Technical Service Bulletin

Cobra Motorcycle Mfg.

TSB0208 CFD upgrade for 50's

November 8, 2007

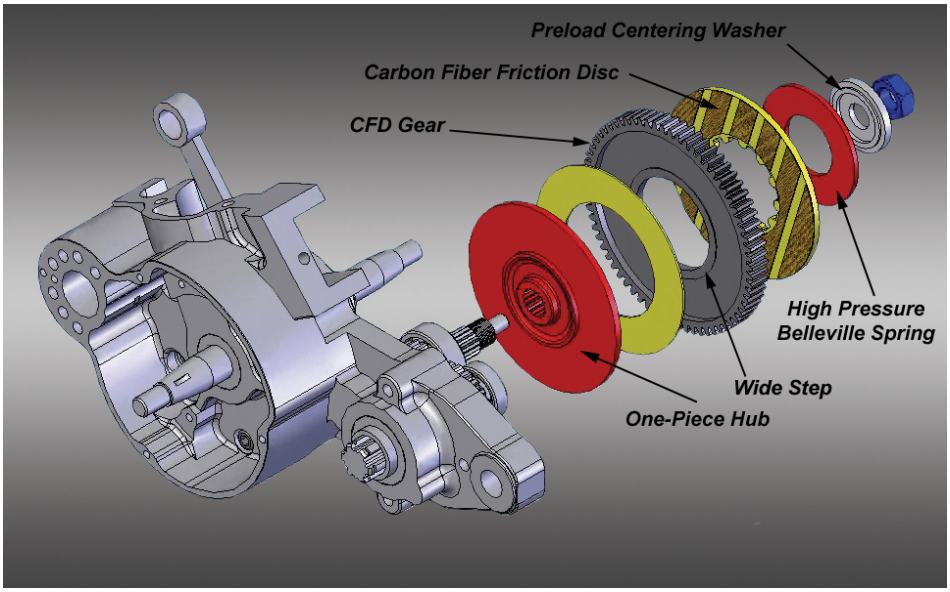
Cobra has discontinued the CFD replacement hardware for all 2006-2007 Cobra 50cc models. When CFD friction material needs replacing it will be necessary to upgrade to 2008 CFD components available in a kit EKMU0005.

The kit includes the following parts:

- One-piece hub / pressure plate
- Single friction paper
- 08 Friction gear
- Bonded pressure plate
- High pressure Belleville spring
- Centering washer
- Blue nut

Upon assembly torque the blue nut to 55 ft-lb (75 N-m)

CAUTION:
The blue nut has left hand threads (turn clockwise to loosen)

CAUTION:
Install the CFD gear such that the wide step is 'in' toward the loose paper & one piece hub / pressure plate. Current production gears do not have a wide step on either side, and can be installed either way.

NOTE
After assembly confirm that slip torque is between 55-92 ft-lb (75–125 Nm) using Cobra CFD holding tool EAMU0004.
